To: **Chair Malone**, Board of Commissioners members **Wyse** and **Shepherd**

From: Valley Neighbors for Environmental Quality and Safety (VNEQS)
<https://coffinbuttefacts.org>
North Benton County
Oregon, 97330

Re: LU-24-027 Response: Maul Foster Alongi correspondence, dated January 27, 2026
Record ID. BOC4_BC0025 - Jan 27, 2026 - [EngineeringOdorDEQPEN_THIRDPARTYREVIEW](#)

ATTACHMENT #1 -- THERMAL INVERSION

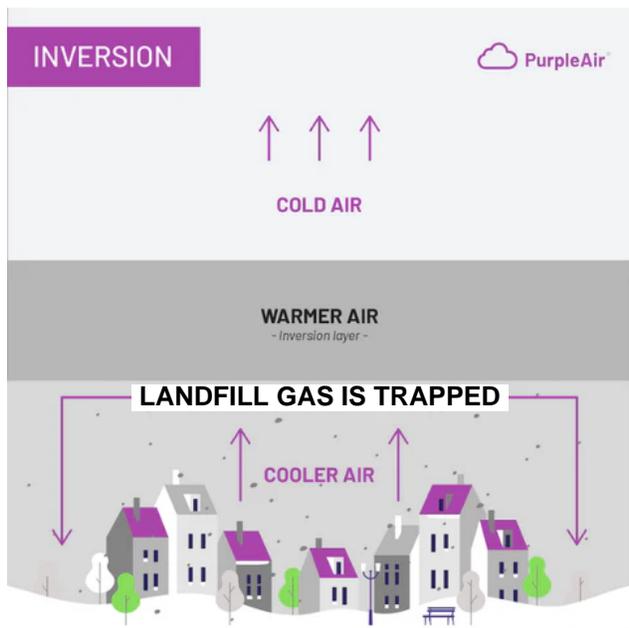
Such fog has been locked in the Willamette Valley for several long stretches in January and February 2022 due to temperature inversions, where warm air high in the atmosphere moved in over the cooler, denser air in the lowlands. Normally, temperatures are warmer at the land surface, cooling higher up in the sky. This allows for most of the rising air and pollutants to continue to disperse out into the atmosphere. But an inversion acts like an atmospheric “lid” that can trap moisture and air pollution in a valley for days.
